GRADING AND EROSION CONTROL PLAN

WYOMING ESTATES SUBDIVISION EL PASO COUNTY, CO

Markup Summary

DRAINAGE, GRADING
AND EROSION
CONTROL COVER

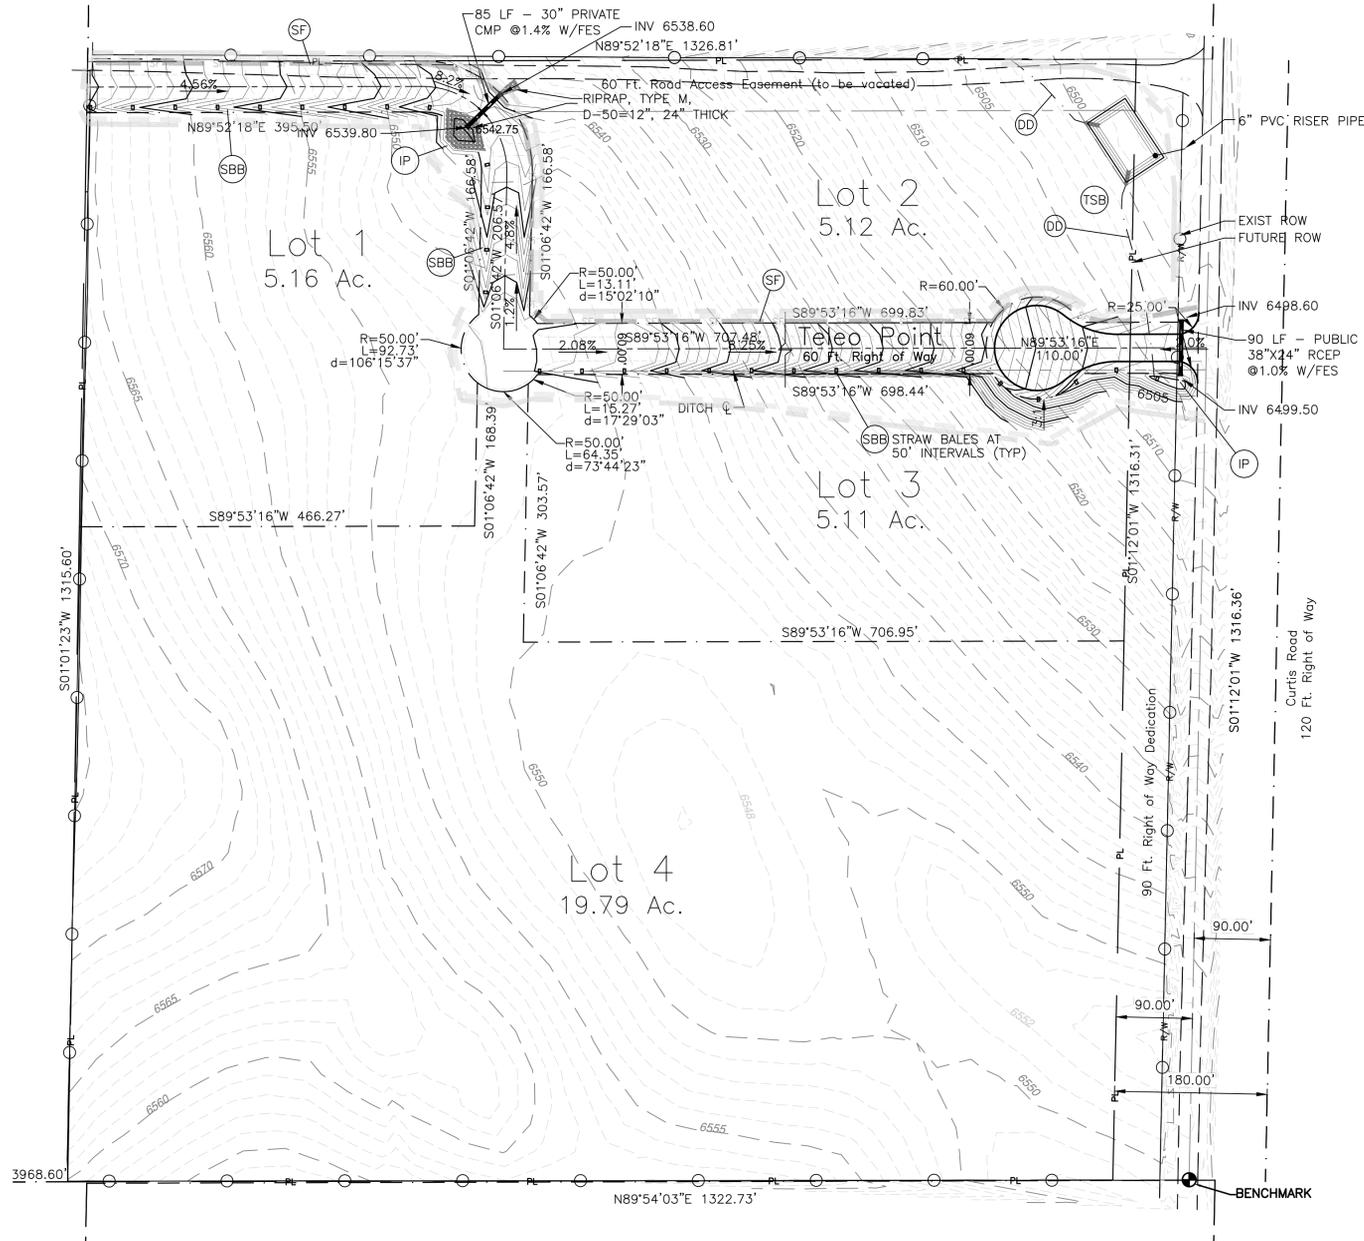
Please remove extra signature blocks, typical.

DRAINAGE, GRADING
 AND EROSION
 CONTROL PLAN

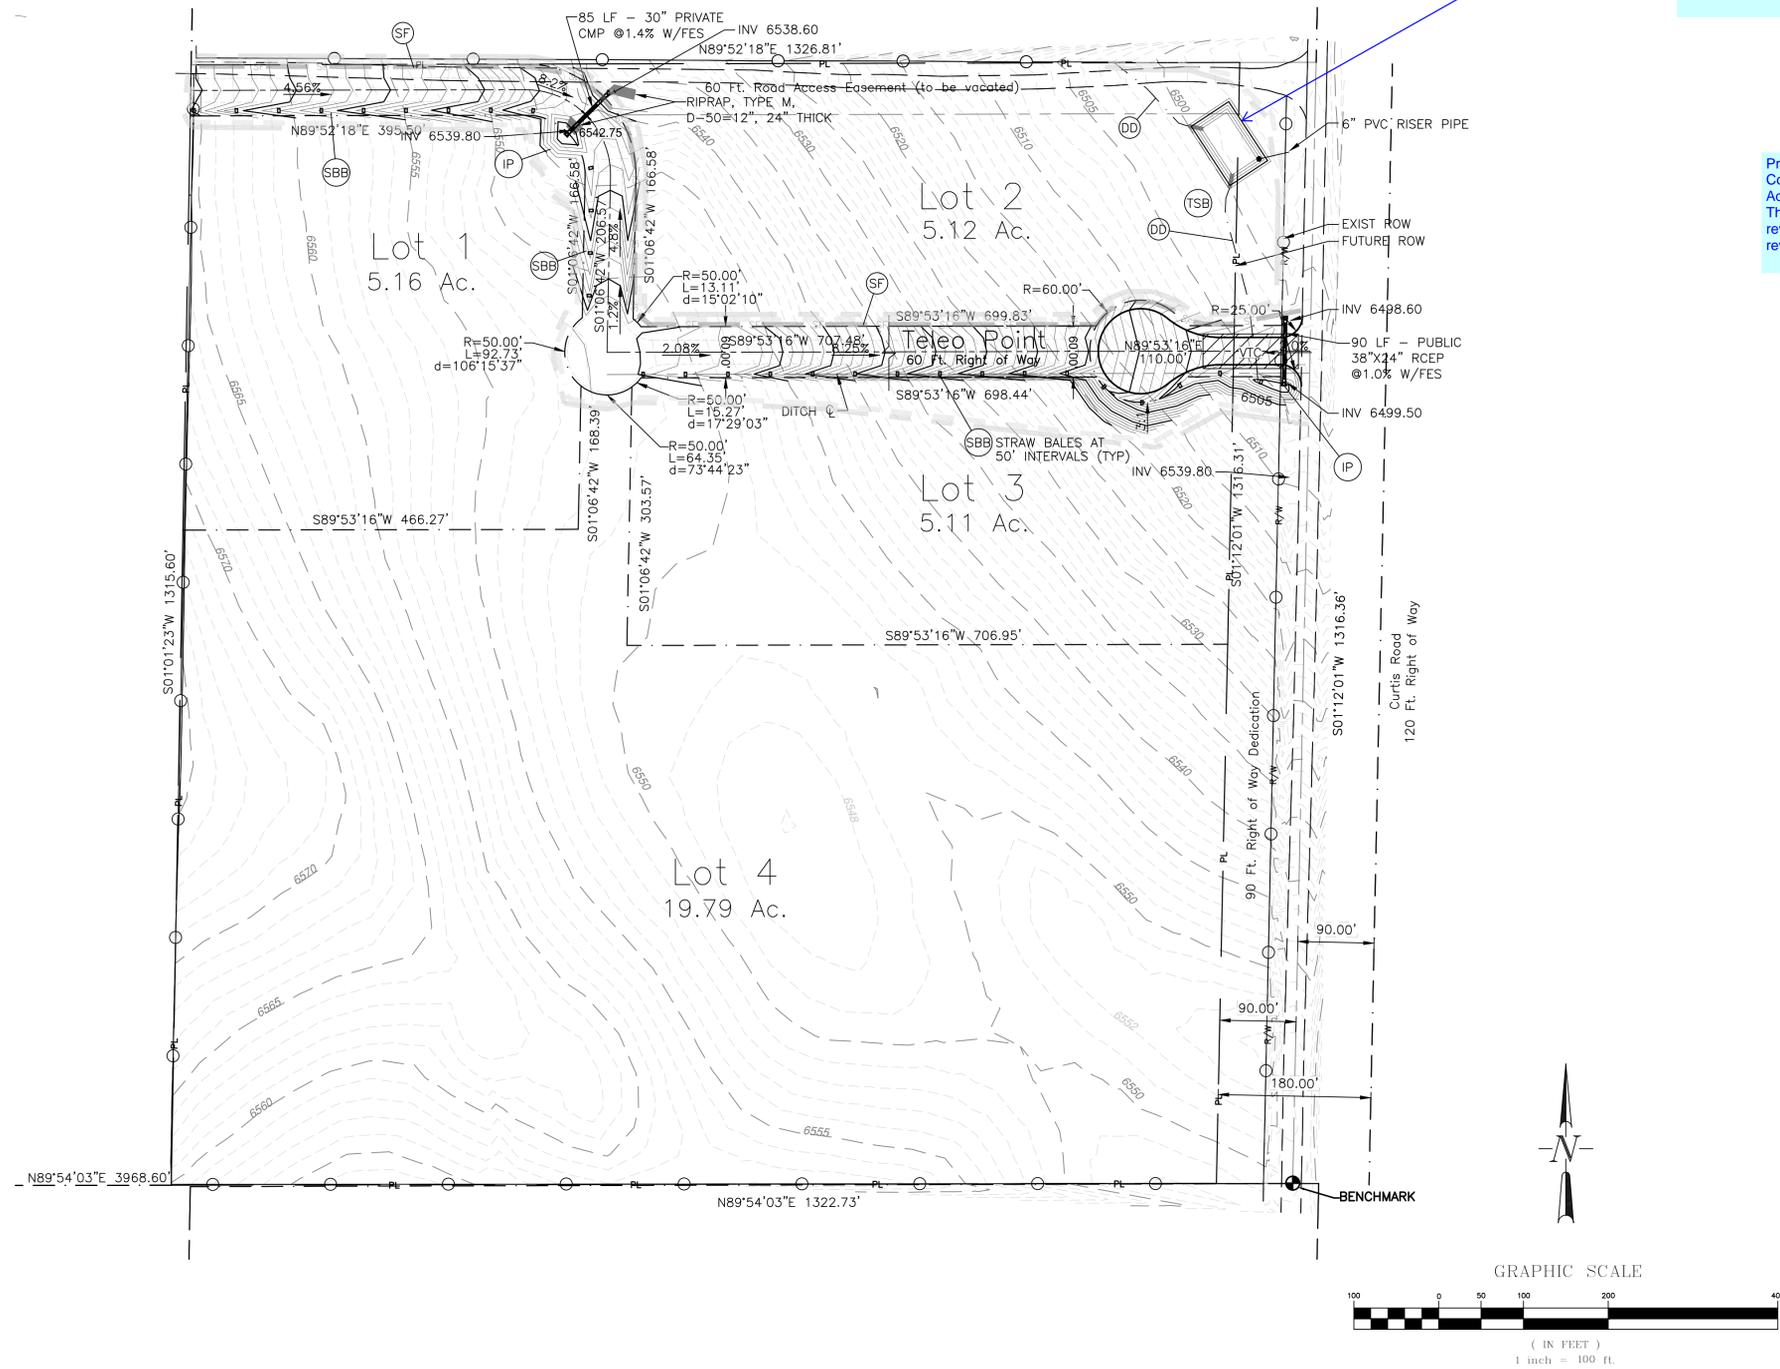
Due to comments provided on the construction plans a redesign of the roadway is expected. A full review of the GEC plan will be done with the resubmittal.

Identify the required and provided sediment basin volume and all riser pipe construction information.

Show the location of the staging area and provide details for inlet protection and stabilized staging area.

Provide new El Paso County Grading and Erosion Control Plan notes. Additionally fill out and submit the new GEC checklist. The new notes and checklist are included in the ECM revisions. See attached Resolution with ECM revisions.
